Access Compliance Report Public Rights-of-Way (Curb Ramps)

Main Street: SIENNA_PKWY Cross Street: CROWN_VALLEY_PKWY Location: W

ADA ID: RPRK211101115614 Ramp Type: Type 1 - Perpendicular Diagonal Initial Pass/Fail: Pass Overall Compliance: No Severity Score: 16

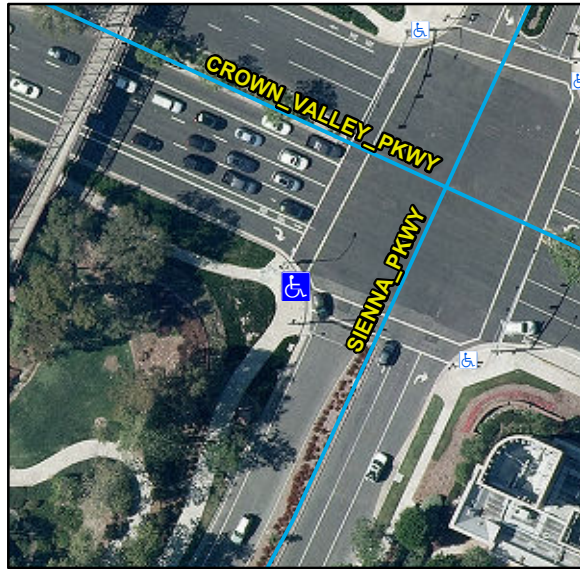
Compliance	Description	Data	Compliance	Description	Data
N/A	Ramp Length (in)	121	N/A	Flare Type LT	
Yes	Ramp Width (in)	48			Sloped
Yes	Ramp Run Slope (%)	7.1	Yes	Flare Slope LT (%)	7.9
Yes	Ramp Cross Slope (%)	0.1	N/A	Flare Traversable LT	Yes
N/A	Landing Present	Yes	N/A	Flare Type RT	
N/A	Landing Length (in)	48			Sloped
Yes	Landing Width (in)	48	Yes	Flare Slope RT (%)	1.6
No	Landing Run Slope (%)	2.2	N/A	Flare Traversable RT	Yes
Yes	Landing Cross Slope (%)	2.1	No	DWS Provided	No
N/A	Landing Movement Obstructed?	No	N/A	DWS Contrast	N/A
	Landing Movement Type	N/A	N/A	DWS Length (in)	N/A
N/A	Landing Shared	No	N/A	DWS Full Width	N/A
Yes	Clear Space	Yes	N/A	DWS Offset Left (in)	N/A
Yes	Clear Space To Crosswalk (in)	48	N/A	DWS Offset Right (in)	N/A
N/A	Marked Crosswalk 1	Yes	N/A	Marked Crosswalk 2	Yes
	Crossing 1 Direction	SE		Crossing 2 Direction	NE
	Marked Crosswalk 1 Width (in)	144		Marked Crosswalk 2 Width (in)	144

Yes	Ramp Inside Crosswalk 1	Yes	Yes	Ramp Inside Crosswalk 2	Yes
	Crossing 1 Slope (%)	2.9		Crossing 2 Slope (%)	3.7
	Crossing 1 Cross Slope (%)	0.6		Crossing 2 Cross Slope (%)	0.8
Yes	Gutter Ponding	No	No	Curb Slope	12.4
Yes	Gutter Lip Height (in)	0		Road Run Slope (%)	2.3
No	Gutter Run Slope (%)	8.5		Road Cross Slope (%)	3.1
Yes	Gutter Cross Slope (%)	1.1			
Yes	Overall Surface Condition: Acceptable		Yes	Perp Joint Present	Yes
	Cross Gutter Present?	No		Spandrel Present?	No
	Replace Cross Gutter?	N/A		Replace Spandrel?	N/A

Remove & Replace Curb Ramp With Two New Directional Ramps or Equivalent. Remove & Replace Gutter.
